THE CORPORATION OF THE TOWNSHIP OF WEST LINCOLN
COMMITTEE OF ADJUSTMENT AGENDA

REPORT NO: COA-018-21

SUBJECT: **Recommendation Report**
Application for Minor Variance by Andrew Frandsen on behalf of
Donna and Byron Hubber
File No. A12/2021WL

REPORT NO: COA-019-21

SKETCH

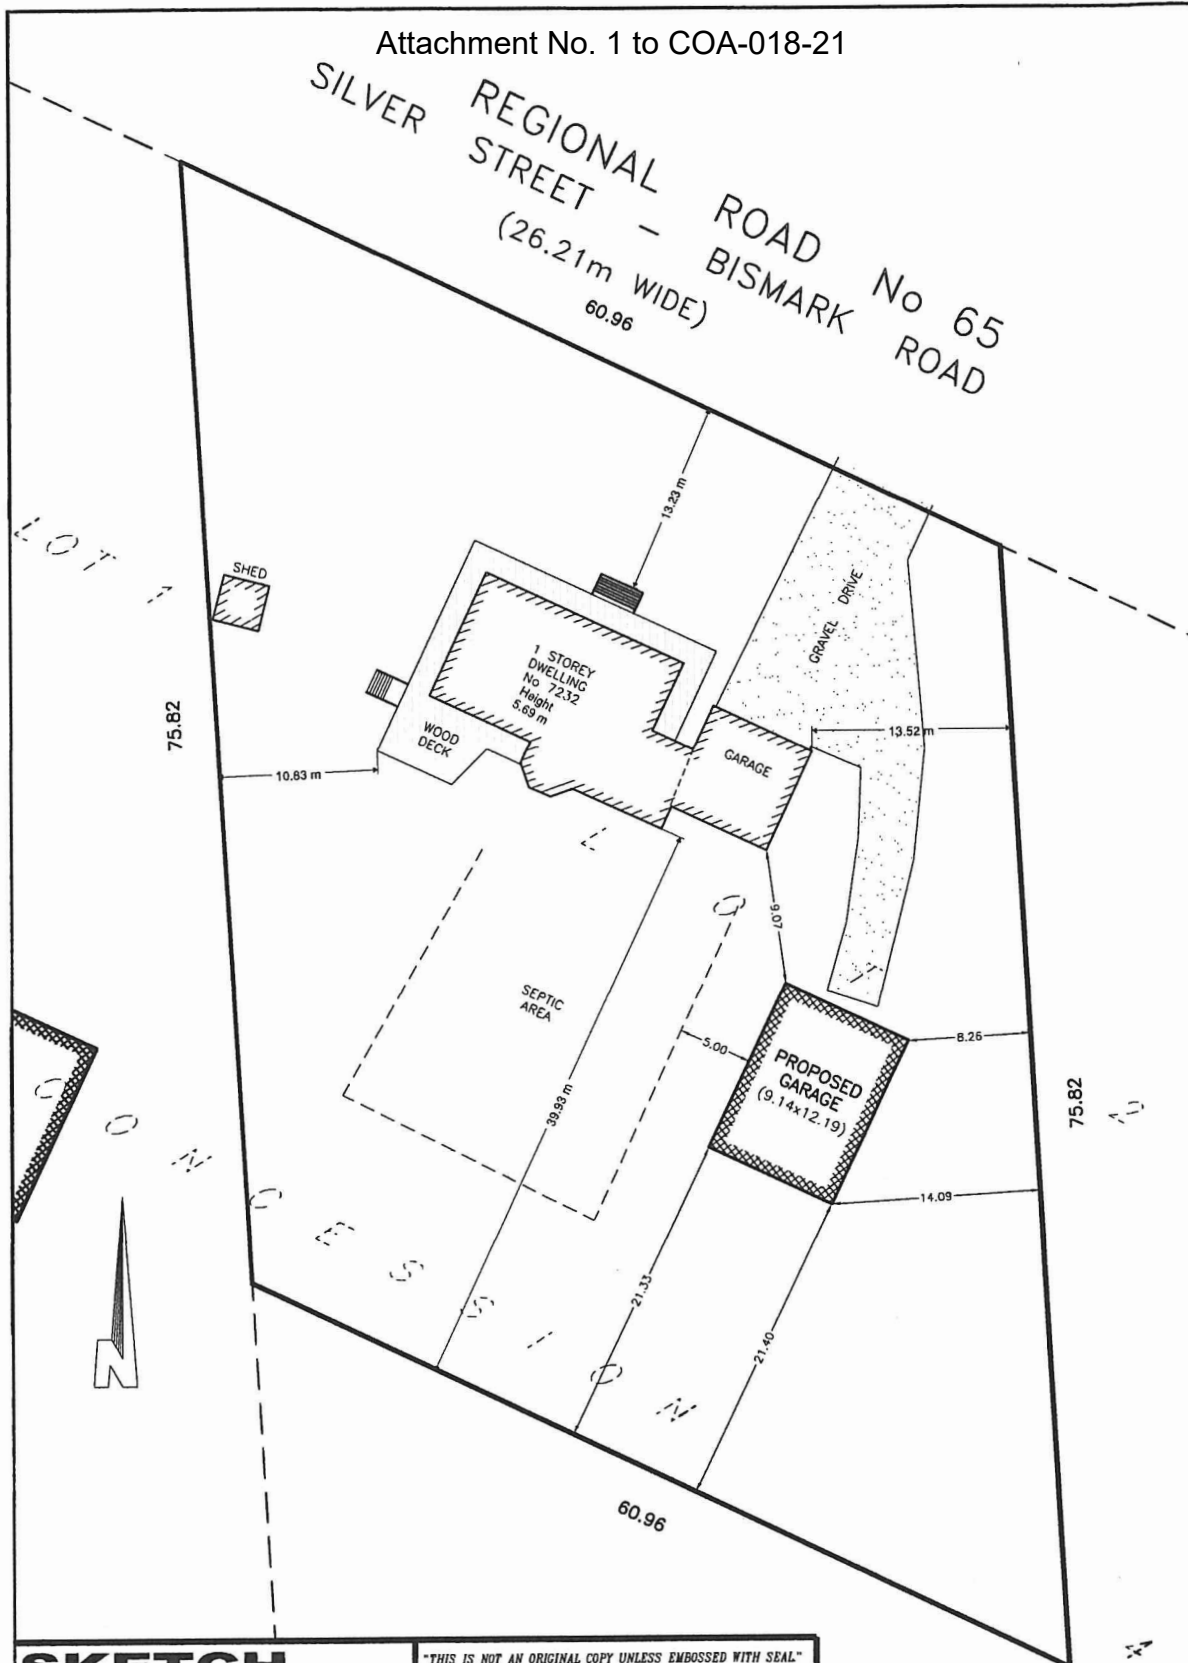
- This Minor Variance application has been applied for to request two variances for a proposed new accessory garage.
- The first variance that is required is to permit an accessory building to be built with a Type 3 accessory building classification with a size of 111.42 square meters (1199.31 square feet) and a height of 5.75 meters (18.86 feet) whereas Table 1-1 of the Township Zoning Bylaw 2017-70, as amended, identifies that Type 3 accessory buildings (greater than 100 square meters) are not permitted on lots with an area of 0.4 hectares or less.

- The second variance that is required is to permit a maximum a lot coverage of 8.4% for all accessory buildings or structures on the lot whereas Table 1-1 of the Township Zoning Bylaw 2017-70, as amended, identifies that the maximum lot coverage for accessory buildings on a lot that is 0.4 hectares or less is 8% of the lot area.

- The first variance has been reviewed against the four tests of a Minor Variance and can be recommended for approval.
- The second variance has been reviewed against the four tests of a Minor Variance and cannot be recommended for approval as it is not required for an accessory garage that is not more than 112 square metres in size.

As the applicant is able to have maximum lot coverage of all accessory buildings or structure that is 8% of their lot area this means that they can have a total lot coverage that equals 323.58 square metres (3,482.99 square feet). Further since the applicant only proposes an accessory garage with a size of 111.42 square meters (1199.31 square feet) Township Planning Staff are not of the opinion that the second minor variance is required and therefore does not meet the general intent and purpose of the Township Zoning Bylaw.

However, Township staff do not believe that the second minor variance that is requesting to increase the maximum lot coverage for accessory buildings is appropriate development or use of the land as there are no plans showing the need for the increase in lot coverage.

1. THAT, the application for the first Minor Variance made by Andrew Frandsen on behalf of Donna and Byron Hubber as outlined in Report COA-018-21, to permit an accessory building be built with a Type 3 classification at a size of not more than 112 square meters and a height of not more than 5.75 metres, BE APPROVED.
2. THAT, the application for the second Minor Variance made by Andrew Frandsen on behalf of Donna and Byron Hubber as outlined in Report COA-018-21, to permit a maximum lot coverage of 8.4% for all accessory buildings or structures on the lot, NOT BE APPROVED.

5352 Elcho Road Property

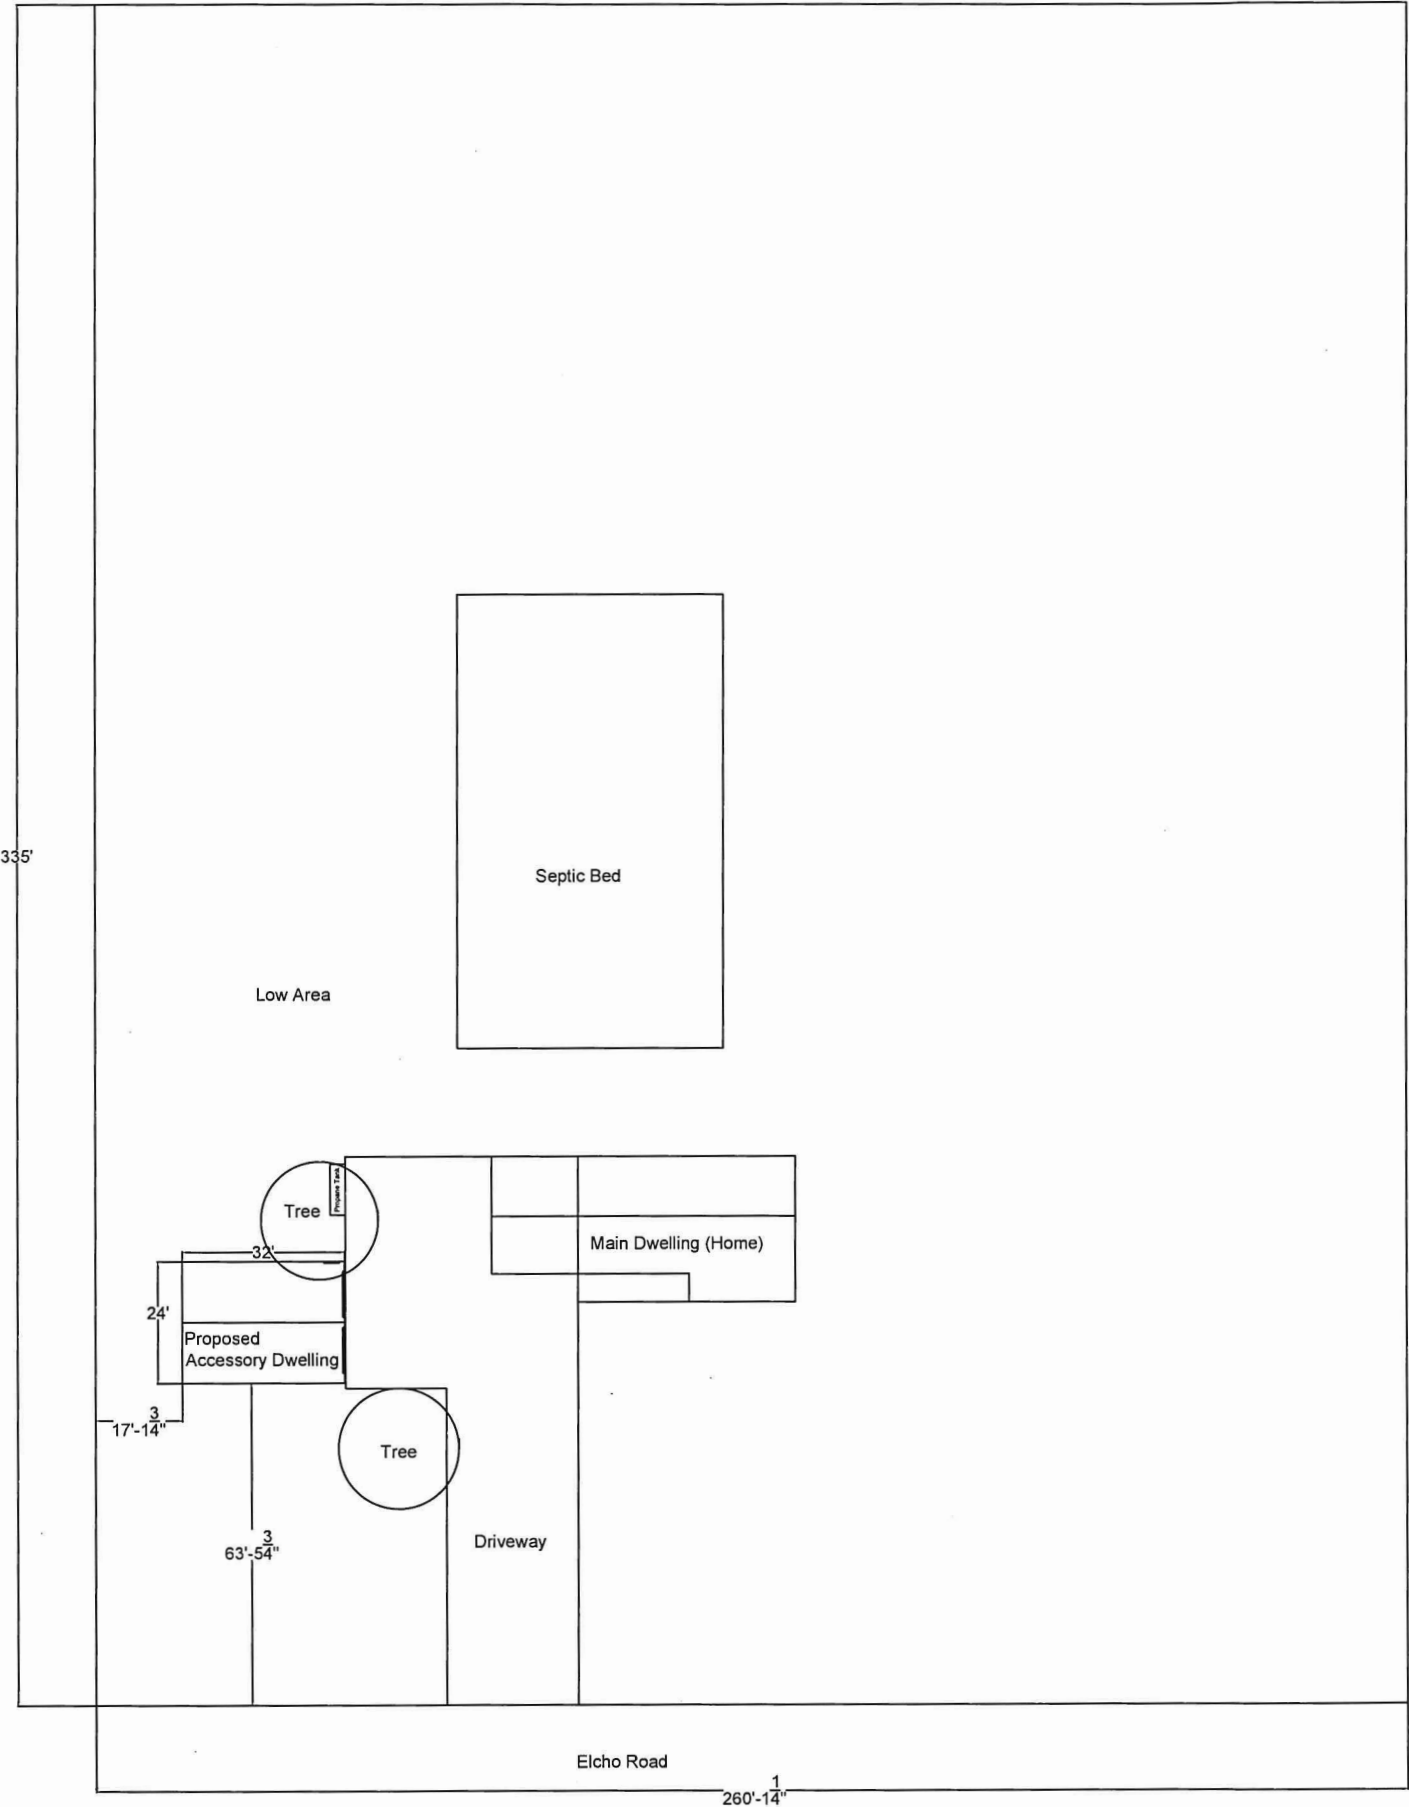
- This Minor Variance application has been applied for to permit an accessory building to be located in the front yard, specifically 3.7 metres (12.14 feet) closer to the front lot line than the main building with a setback of 19.3 metres (63.32 feet) to the front lot line.

The applicant would like to utilize the existing drive way with the accessory building. The drive way runs to the east of the house and to the rear the drive way is the applicant's propane tank and a tree and to the rear of the dwelling is the property's septic bed. To avoid the septic bed, propane tank, and to still utilize the existing driveway the applicant has proposed the accessory building to be positioned roughly 3.7 metres (12.14 feet) closer to the front lot line than the main building with a setback of 19.3 metres (63.32 feet) to the front lot line.

The subject application is requesting to permit a proposed accessory building be built 3.7 metres (12.14 feet) closer to the front lot line than allowed on the property. If the accessory building, which is proposed to be used for storage and as a garage, was attached to the dwelling it would be able to project up to 4 metres closer to the front lot line. However, since it is not proposed to be attached it is not allowed to project from the dwelling to the front lot line.

1. THAT, the application for the Minor Variance made by Cody Kelly as outlined in Report COA-019-21, to permit an accessory building be built 3.7 metres closer to the front lot line than the main building with a setback of 19.3 metres to the front lot line, BE APPROVED subject to a required condition:
 - a. That the Department of Planning and Building approve the exterior design of the accessory building, which shall be alternatively designed in keeping with the residential characteristic of the property.
